EPA Response to Comments

Response to Public Comments

**Class III Area Permit No. SD31231-00000, Aquifer Exemption Decision
And
Class V Area Permit No. SD52173-00000**

**Powertech (USA) Inc.
P.O. Box 448
Edgemont, South Dakota 57735**

Figure J. Locations of earthquakes occurring between 1872 – 2013 in southwest South Dakota from the South Dakota Geological Survey website.

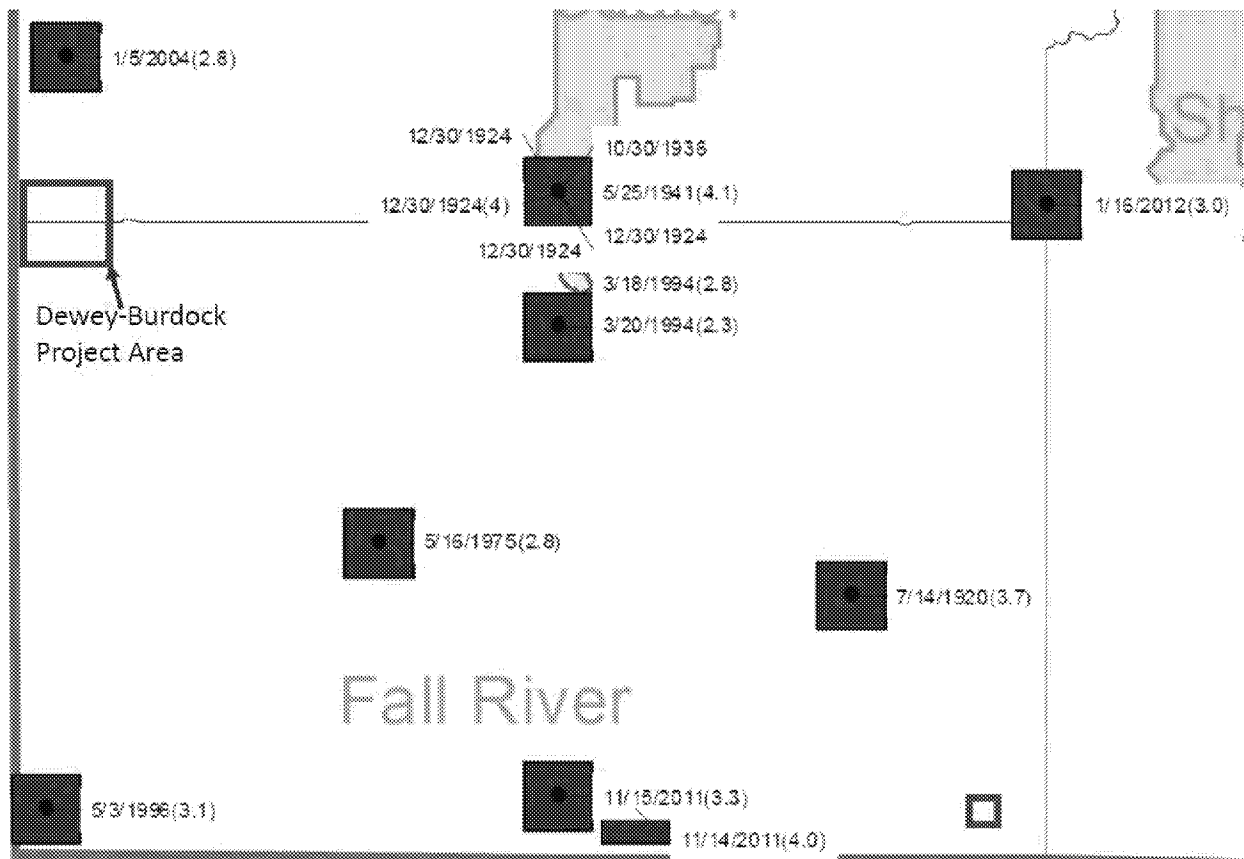
Figure J shows locations of earthquakes that have occurred between 1872 - 2013 in southwestern South Dakota including the earthquakes mentioned by the commenter. This map is available on the South Dakota Geological Survey website.

Figure J shows the nearest recorded earthquake to the Dewey-Burdock Project Site is the one that occurred on January 5, 2004, located north of the Project Site. Figure K shows this earthquake location on the USGS Earthquake Hazards Program interactive map. This earthquake was located at latitude 43.598°N and longitude 103.995°W. This location plotted on Google maps with the Dewey Fault zone location added shows that this earthquake was not located in the Dewey Fault zone.

Figure L. The relative locations of the Dewey-Burdock Project Site and Town of Buffalo Gap locations in the Black Hills and Inyan Kara groundwater flow direction.

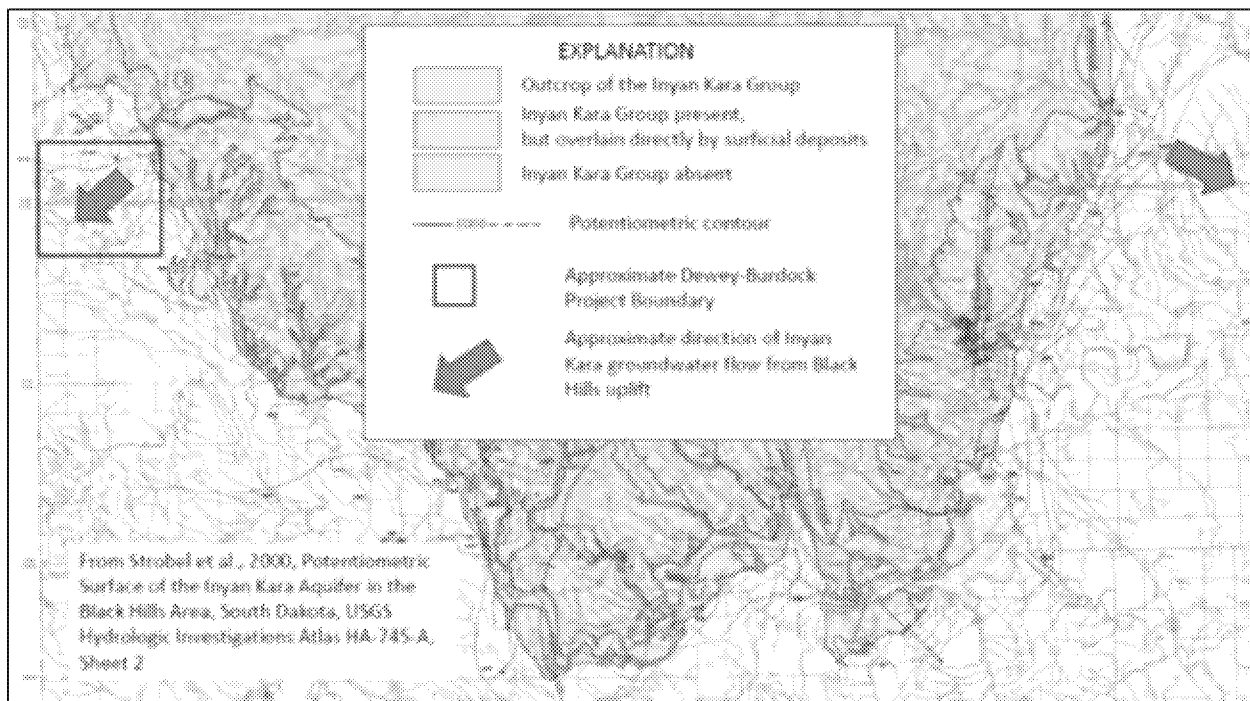
EPA has investigated the injection zone aquifer flow directions from the Dewey-Burdock Project Area relative to the Town of Buffalo Gap, South Dakota. Figure L is the southern portion of Sheet 2 from Strobel et al., 2000, which shows that the Dewey-Burdock Project Site and Buffalo Gap are located on opposite sides of the Black Hills. (Strobel et al., 2000). The Inyan Kara aquifer groundwater flow at the two locations is in opposite directions, as indicated by the potentiometric surface contours that approximately follow the dip of geologic strata away from the Black Hills uplift.

Figure N. Elevation of the Minnelusa Formation top surface (Source: Carter and Redden, 1999, Sheet 2)

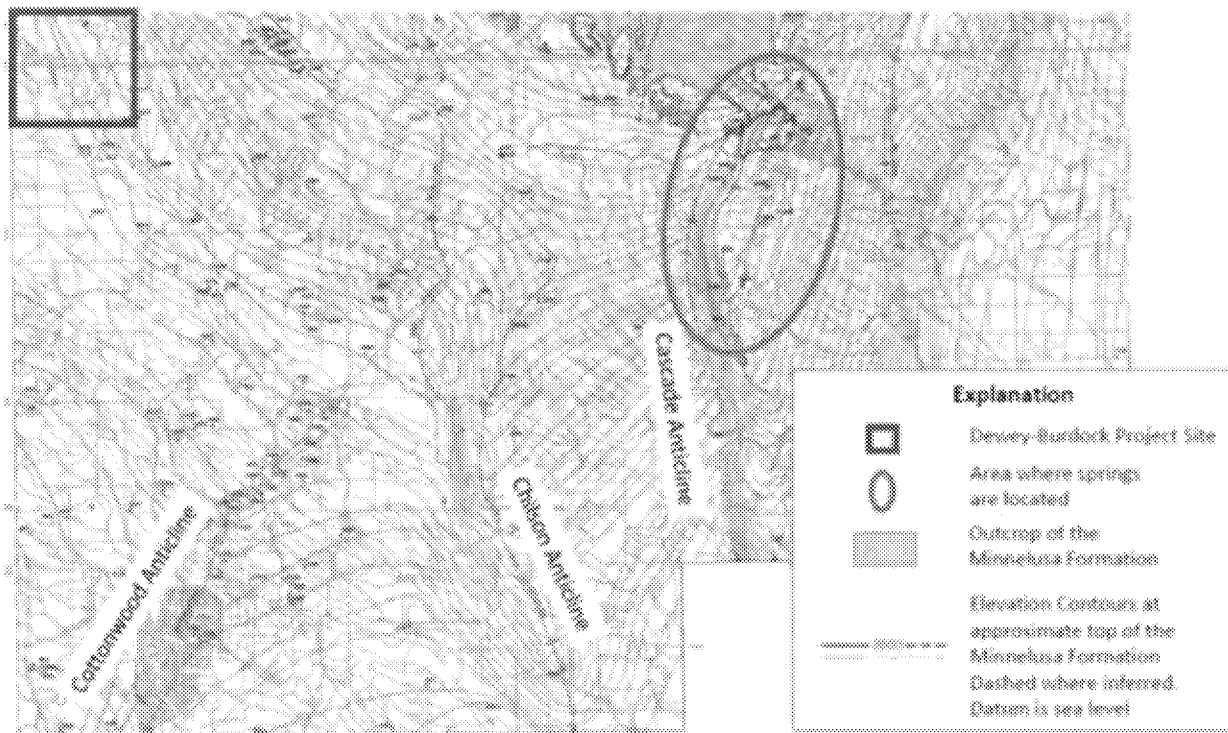
locations where the Minnelusa groundwater flows to the ground surface are at springs near the Minnelusa outcrop around the Black Hills. Figure N shows the elevation of the top of the Minnelusa Formation from the Sheet 2 map from Carter and Redden, 1999. (Carter and Redden, 1999, Sheet 2) The springs are located in the green circle in Figure N; the Dewey-Burdock Project Area is located inside the blue square. The Minnelusa Formation where the springs are located, occurs at a higher elevation than the Minnelusa injection zone in the Dewey-Burdock Project Area. Although the Minnelusa Formation top elevation is not the same as the aquifer groundwater level and the direction of the Minnelusa Formation dip is not exactly the same as the groundwater flow direction, relative formation top elevation and direction of formation dip are a useful approximation in this case. EPA concludes that injectate flowing from the Dewey-Burdock Project Site would have to flow uphill/upgradient to reach these springs and thus would not reach the locations of these springs. In addition, the Cottonwood, Chilson and Cascade anticlines located south of the Black Hills are like hills raising the Minnelusa Formation top to a higher elevation and deflect Minnelusa groundwater flow further south away from the locations of these springs.

Based on this analysis, EPA concludes the Class V disposal well injectate will not travel to the locations of Minnelusa springs to be discharged to the ground surface; therefore, Class V injection activities will not impact surface water, including the Cheyenne River, the Cheyenne River Indian Reservation, the Pine Ridge Indian Reservation, or other downstream communities.

Figure O. Screenshot of the South Dakota Surface Water Quality Standards map (Impairment Status tab) showing drainage basin boundaries as green-dashed lines.

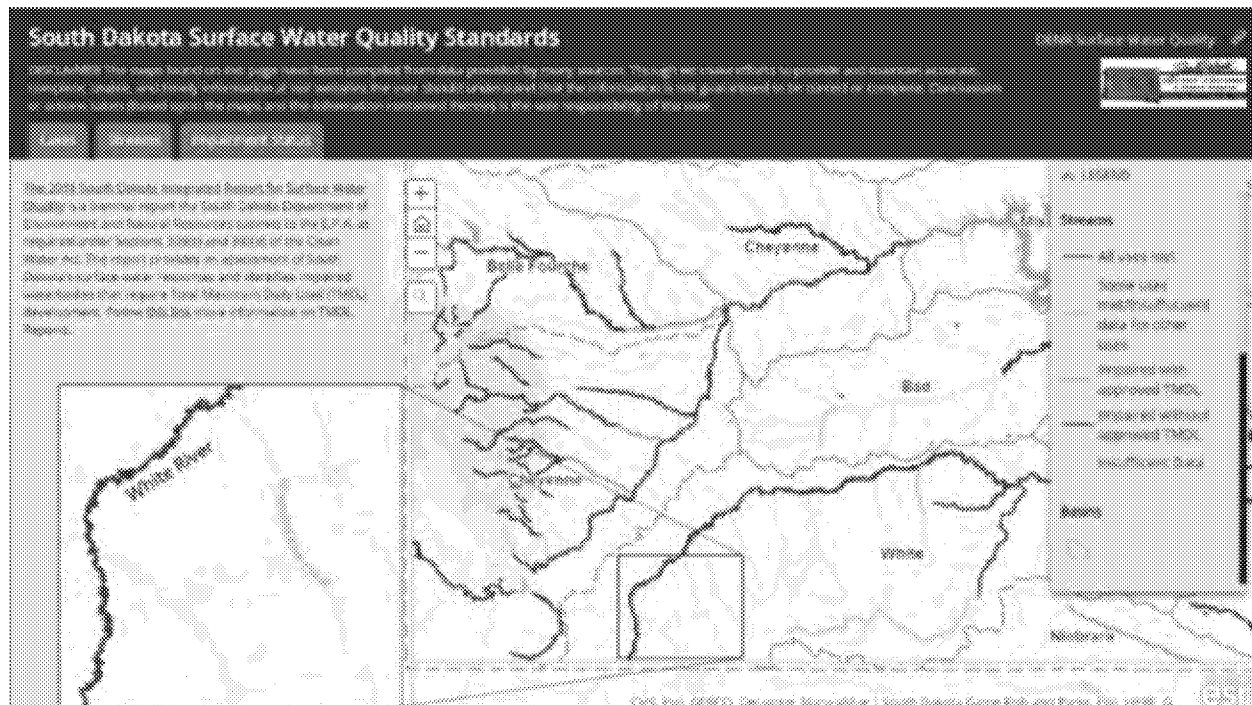
In addition to the explanation above, Figure O below is a screen shot of the South Dakota Surface Water Quality Standards map (click on Impairment Status tab). The green-dash lines are river drainage basin

boundaries. The enlarged portion of the map shows that Wounded Knee Creek is located in the White River drainage basin. The Dewey-Burdock site is located in the Cheyenne River basin and there is no surface water connection between the Dewey-Burdock Project Site and the White River drainage basin. Based on the geography of the White River drainage basin, it does not receive surface water originating from the Black Hills. Therefore, the Dewey-Burdock Project will not affect the White River drainage basin including the area around Wounded Knee Creek.

Figure P. Minnelusa aquifer groundwater flow direction map from Figure 17, Driscoll et al., 2002

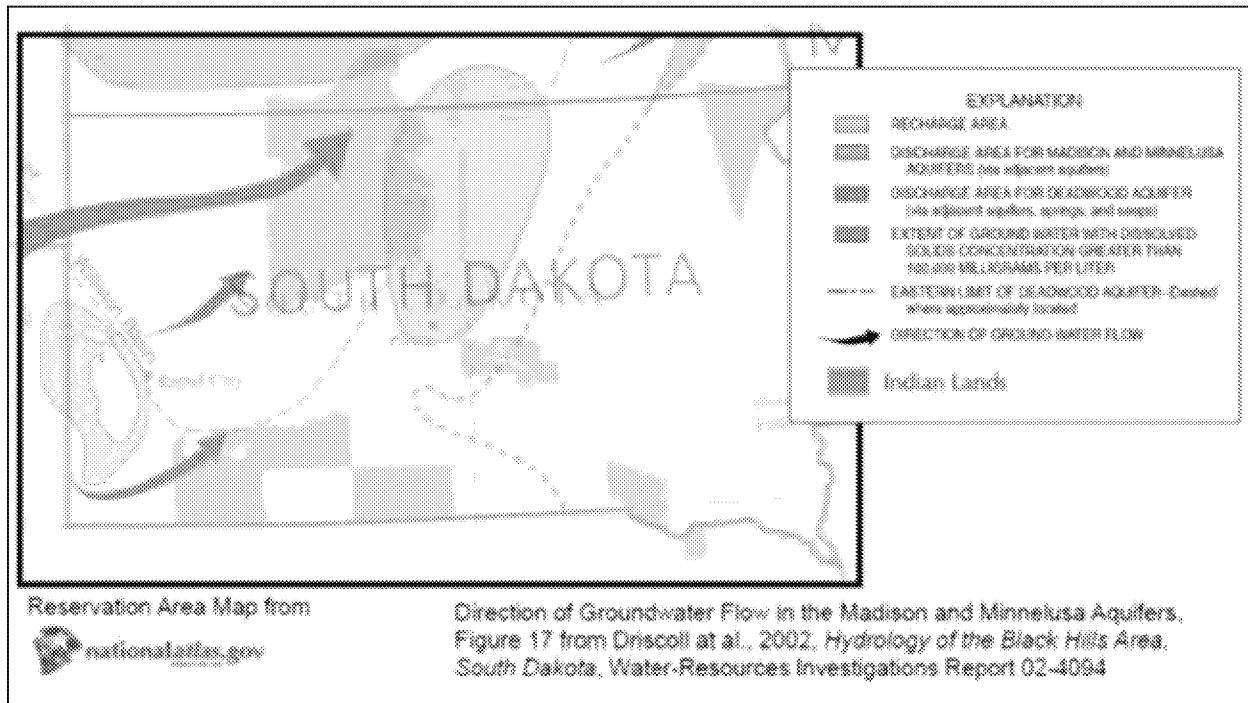
EPA investigated groundwater flow directions in the Minnelusa aquifer relative to the Pine Ridge and Cheyenne River Reservations. Figure P is a groundwater flow direction map from Figure 17 in Driscoll et al., 2002. This map shows the direction of groundwater flow in the Minnelusa aquifer from its recharge

area in the Black Hills to a discharge area identified in this paper. As shown in the map in Figure P, the authors hypothesize that the Minnelusa aquifer groundwater flows from the Dewey-Burdock site and around the southern end of the Black Hills toward the Williston Basin, crossing underneath the northwestern portions of the Pine Ridge Reservation. The map shows a discharge area for the Madison and Minnelusa aquifers in an area that coincides with the eastern portion of the Cheyenne River Indian Reservation.

Figure Q. Locations of springs emanating from or passing through the Minnelusa aquifer, from Figure 8 of Naus et al., 2001.

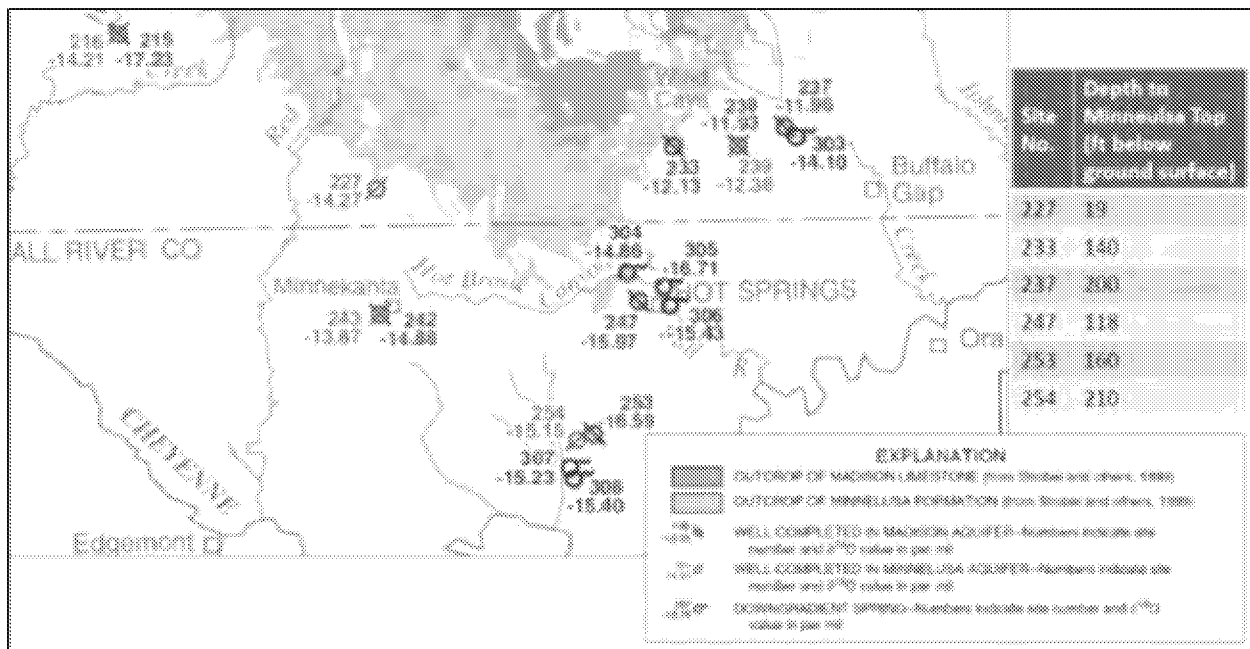
EPA examined oil and gas test wells located near the northwest portion of the Pine Ridge Indian Reservation to determine the depth of the Minnelusa aquifer in the area and found the top of the Minnelusa aquifer is more than 3,800 feet below ground level in this area, which is too deep to flow to ground level. Springs emanating from, or passing through, the Minnelusa aquifer occur where the top of the Minnelusa aquifer occurs closer to the ground level. For example, at the springs shown in Figure Q, from Figure 8 of Naus et al. 2001, the top of the Minnelusa is approximately 200 feet or less below ground level, based on nearby private well logs. Based on the elevation of the top of the Minnelusa Formation shown in Carter and Redden, 1999, the springs occur in areas located at a higher elevation than the Minnelusa injection zone at the Dewey-Burdock Project Site. Carter and Redden, 1999, provides estimates of how the Chilson and Cascade anticlines affect the Minnelusa Formation elevation. As a result, the flow path of Class V injectate would be deflected to the south and would essentially have to flow uphill to reach these springs where Minnelusa groundwater flows to the surface.

Figure R. Map showing area of possible upward leakage from the Madison and Minnelusa aquifers into Inyan Kara aquifers and extent of the Arikaree and Ogallala aquifers (Sources: Peter et al., 1986, Figure 8 and Weeks, et al., 1988, Figure 1)

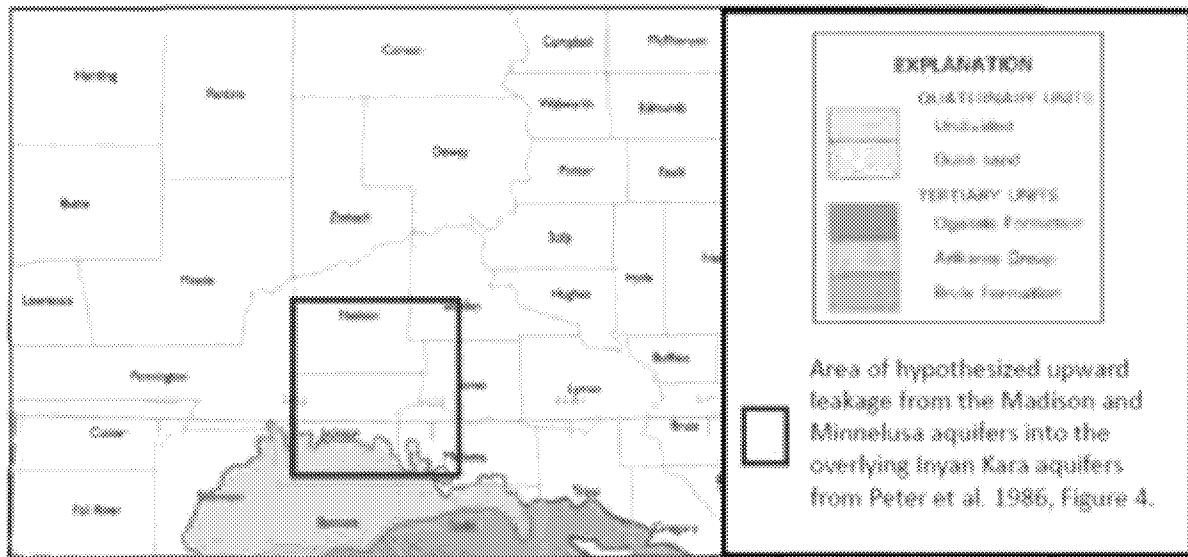
Based on lineament analysis and review of Inyan Kara groundwater quality data, Peter et al., 1986, hypothesized upward leakage from the Madison and Minnelusa aquifers into the Inyan Kara aquifers in an area within portions of Jackson, Melette, Haakon, Stanley and Jones Counties in South Dakota. (Peter, K.D., et al., 1986, *Lineaments: Significance, Criteria for Determination, and Varied Effects on Ground-Water Systems—A Case History in the Use of Remote Sensing*, Geotechnical Applications of Remote Sensing and Remote Data Transmission, ASTM STP 967, A. I. Johnson and C. B. Pettersson, Eds., American Society for Testing and Materials, Philadelphia, 1988, pp. 46-68.) Figure R shows the location of this area overlaid on a map of the Arikaree and Ogallala aquifers in South Dakota documented in Weeks, et al., 1988. (Weeks, J.B., et al, 1988, *Summary of the High Plains Regional Aquifer-System Analysis In Parts of Colorado, Kansas, Nebraska, New Mexico, Oklahoma, South Dakota, Texas, and Wyoming*, USGS Professional Paper 1400-A, at p. A4) Upward leakage from these lower aquifers into the Inyan Kara aquifers does not necessarily result in upward leakage into the overlying Arikaree and Ogallala aquifers in this location. EPA reviewed logs from oil and gas test wells in Jackson County and determined the top of Inyan Kara is 2800 to 2900 feet below ground surface. Approximately 2000 feet of overlying strata, most of which are confining zones, separate the top of Inyan Kara aquifer from the Arikaree and Ogallala aquifers. EPA concludes that Inyan Kara groundwater does not flow into the Arikaree and Ogallala aquifers on the Pine Ridge Indian Reservation.

EPA has investigated the area identified as a discharge area for the Minnelusa and Madison aquifers in the area shown in Figure P that coincides with the eastern portion of the Cheyenne River Reservation. The discharge area represents the area where Madison and Minnelusa groundwater is moving upward into the Inyan Kara aquifers (Downey, J.S and Dinwiddie, G.A, 1988, *The Regional Aquifer System Underlying the Northern Great Plains in Parts of Montana, North Dakota, South Dakota, and Wyoming-Summary*, USGS Professional Paper 1402-A). Based on oil and gas test well logs EPA reviewed, the depth to the top of the Minnelusa aquifer in the area of discharge is approximately 3,000 feet below ground level and the top of the Inyan Kara aquifer is approximately 2,000 feet below ground level. According to Howells, 1979, (Sheet 1) the Pierre Shale is present at the surface of the eastern portion of the Cheyenne River Indian Reservation. (Howells, L., 1979, *Geohydrology of the Cheyenne River Indian Reservation, South Dakota*, USGS Hydrologic Investigations Atlas HA-585, Sheet 1) Most of the intervening geologic units between the top of the Inyan Kara, including the Pierre Shale, are confining units. Based on this information, EPA concludes that neither the Minnelusa nor the Inyan Kara injection zones discharge to ground level at the Cheyenne River Indian Reservation. EPA examined test oil and gas well logs and found that along the eastern edge of the Cheyenne River Indian Reservation the top of the Inyan Kara ranges from 1500 in the southeast to 2800 in the northeast. The top of the Inyan Kara deepens from south to north as it descends further into the Williston Basin. Driscoll et al., 2002, characterizes Inyan Kara groundwater as moderately saline with increasing salinity toward the deep parts of the Williston and Powder River Basins. Because of the depth and salinity of the Inyan Kara aquifers at the Cheyenne River Indian Reservation, these aquifers would not be developed for use.

Figure T. Pass Creek alluvium cross-section and the Burdock Area Pond locations for the Class V disposal option.

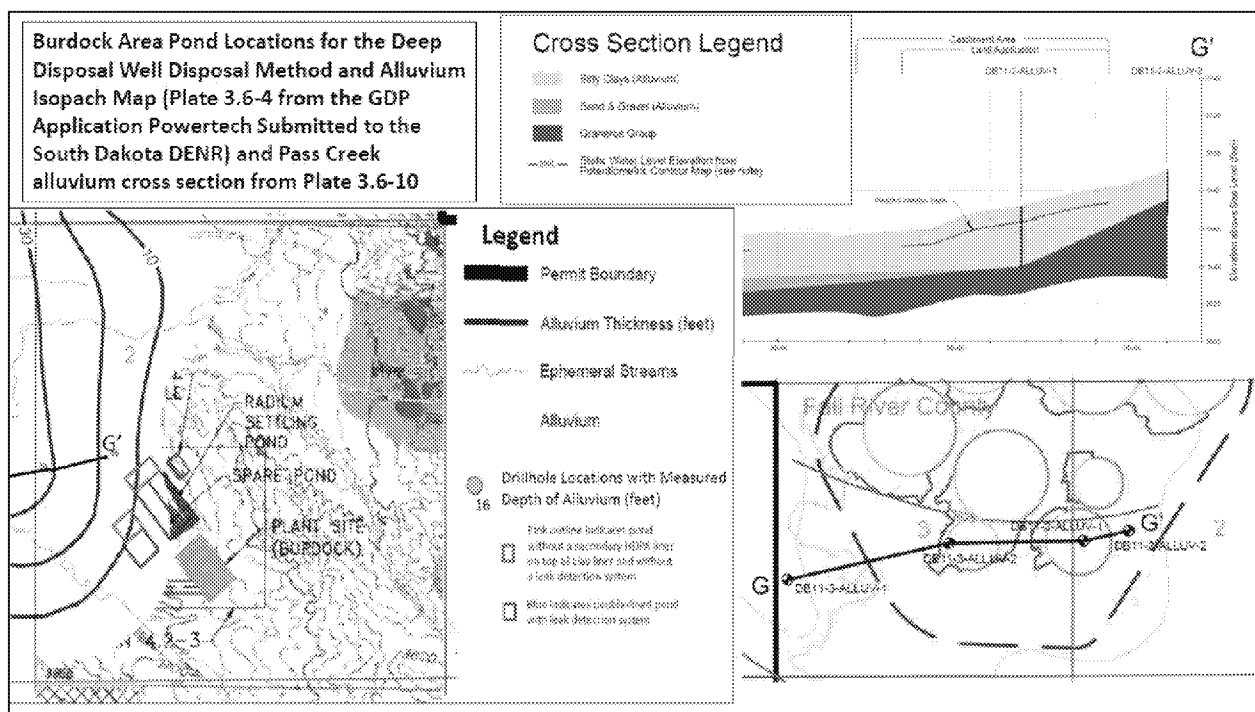
EPA does not agree with Powertech about the potential impacts from a pond leak in this area. EPA performed an analysis of the geological conditions underlying the Burdock Area Ponds to evaluate impacts from the potential leaking of ponds. EPA has concerns that although the ISR waste fluids would have been treated to remove radium, the stored water would still contain byproduct material and high TDS reject water from the reverse osmosis treatment system. Leaking from ponds in this area have the potential to affect alluvial aquifers. Plate 3.6-10 in the Groundwater Discharge Permit Application shows cross-sections of the Pass Creek alluvium and Appendix 3.6-A contains logs from Pass Creek alluvial

Because of EPA's concern about potential effects to these alluvial aquifers, EPA included a condition in Part II, Section I.4.a of the Class III Area Permit requiring the Permittee to submit information to the EPA Region 8 Air and Radiation Division to determine the applicability of the 40 CFR part 61, subpart W regulations, and if necessary, receive construction approval from EPA. If CAA subpart W applies to these ponds, Powertech will need to meet subpart W requirements. The surface impoundment design, construction, and operating requirements are found under 40 CFR § 264.221(c) which requires two or more liners, installation of a leak detection system, and a leachate collection and removal system between such liners.
